HISTORIC PRESERVATION ADVISORY BOARD CASE MEMO

**TO:** Historic Preservation Advisory Board

**DATE:** April 18, 2019

CASE NUMBER: H2019-003; COA for 925 N. Goliad Street

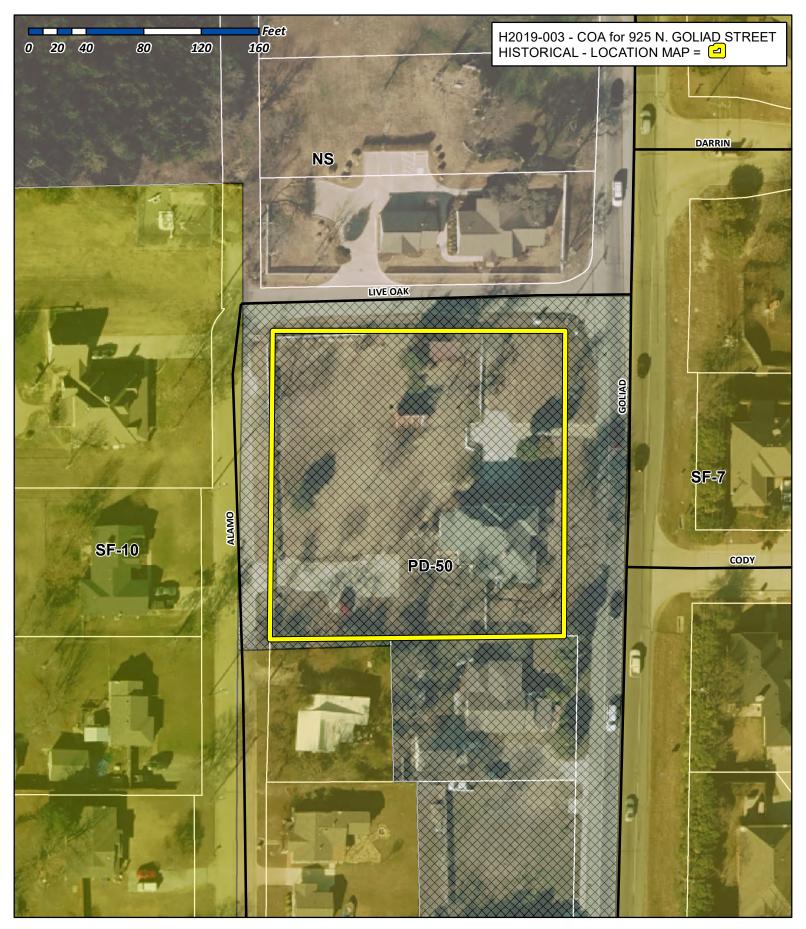
According to Subsection 6.04.E, *Parking Area Restrictions*, of Section 6, *North Goliad Corridor Overlay (NGC OV) District*, of Article V, *District Development Standards*, of the Unified Development Code (UDC), "...any surface parking shall be provided in well-screened parking lots at the rear or behind the main façade of the building..." Additionally, new buildings or alterations shall be compatible with the adjoining area. In this case, the relocation of the parking lot and sidewalk from the front of the building to the rear brings the building into conformance with the overlay district standards with regard to location of parking lots. Additionally, since the applicant is utilizing the existing fence and additional landscaping as screening, the request appears to be in conformance with the overlay district with regard to screening of parking lots. Since, the structure is being converted from a residential land use to a commercial land use, it is expected that modifications to the exterior will be required. In this case, the applicant is proposing to utilize railing that appears to match the style of the building. Since the

sidewalk will be located toward the side of the structure, it will have limited visibility from the street. Staff should note, although the property is a *Landmarked Property*, the applicant's request does not appear to negatively impact the subject property or the neighboring properties and approval of this request is discretionary to the Historic Preservation Advisory Board (HPAB). Should this request be approved, staff would recommend that landscape screening be provided adjacent to the ramp.

- (1) The developer shall plant a thick vegetative screening utilizing a combination of accent trees, bushes and/or grasses adjacent to the ramp and the south property line; and
- (2) The developer shall submit a revised landscape plan showing the location and landscape materials proposed for the landscape screening adjacent to the ramp and south property line; and
- (3) Any construction resulting from the approval of this site plan shall conform to the requirements set forth by the Unified Development Code (UDC), the International Building Code (IBC), the Rockwall Municipal Code of Ordinances, city adopted engineering and fire codes and with all other applicable regulatory requirements administered and/or enforced by the state and federal government.
